Drawing M-4952 Rev. AY
Zone F/G - 7/8

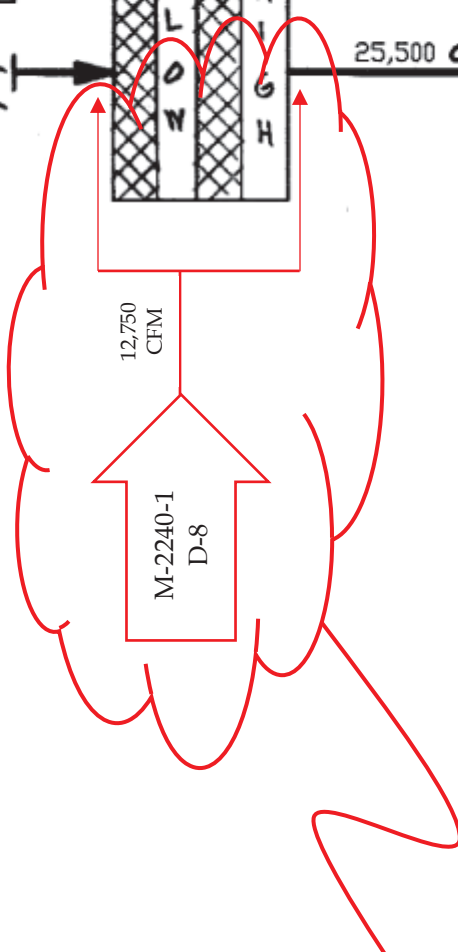
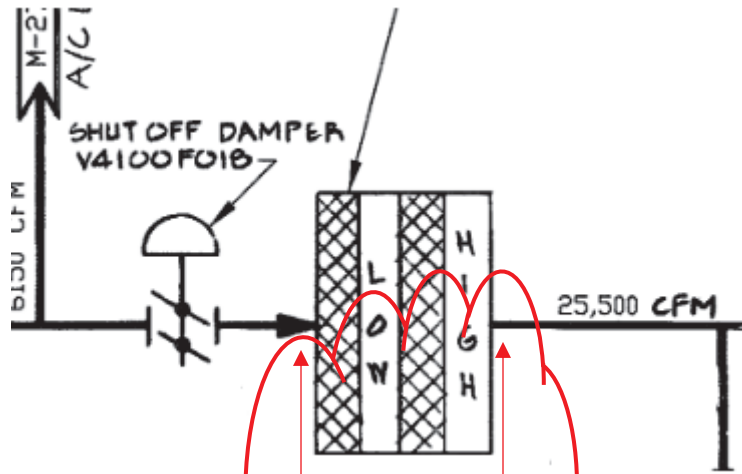
Add per TM 20-0025 Rev 0
